ADVANCE AUTO PARTS

GRADING & DRAINAGE AREA PLAN

C5.0

**Re: Advanced Auto Parts
San Mateo / Claremont
Grading & Drainage Plan (H17D111)**

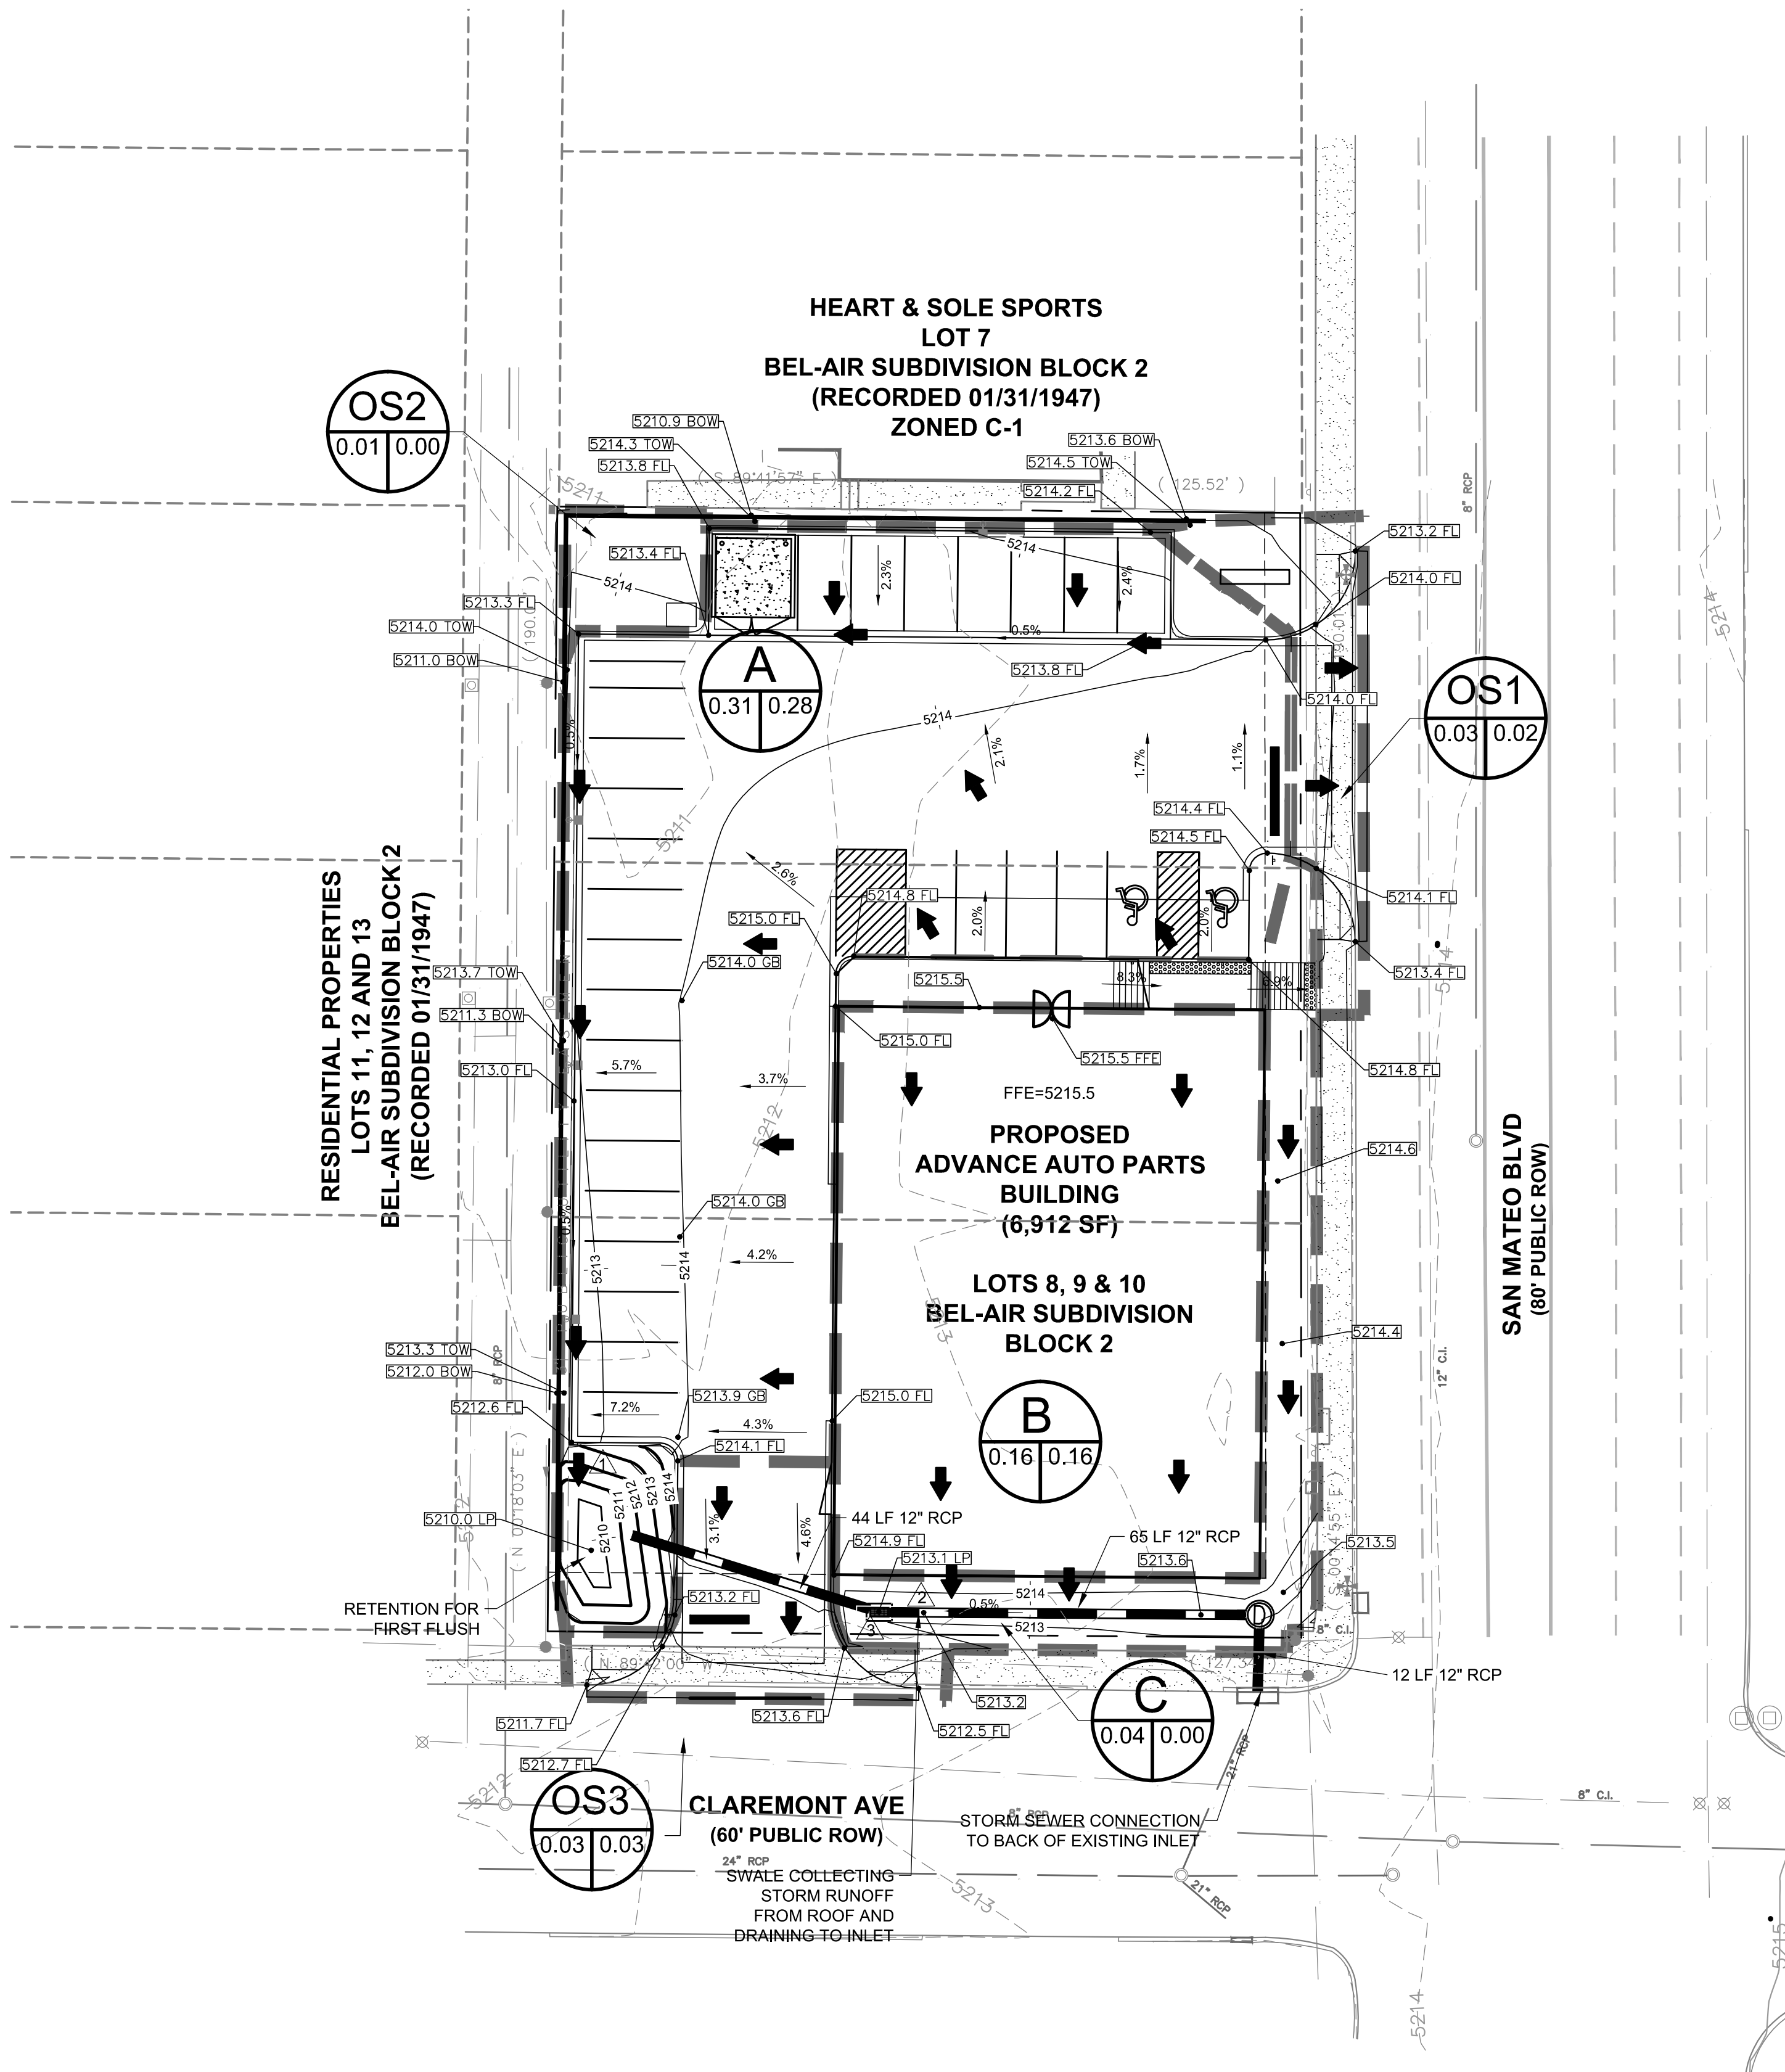
However, this plan cannot be accepted by the Hydrology section for Grading Permit and Building permit until the DRB has approved the replat of this site and the plan is signed and dated by the engineer of record and the following comments addressed.

- Provide a detail on the plan for the swales.
- Provide an invert for the pipe in the pond.
- An SO 19 permit is needed for work in a public right of way. Provide SO-19 comments on the plan.
- Provide the detail for OS2 or is this area along with the NE corner landscaped areas?
- Depress all landscaping which is not within 10 feet of the building.
- A 2ft curb cut is needed on the north side of the pond.
- An emergency overflow is needed for the pond. Direct the emergency overflow for the pond toward the drive pad in Claremont.
- Provide a Floodplain Permit for this site. Also, before CO is given for this site a LOMR-F must be completed and an elevation certificate provided.
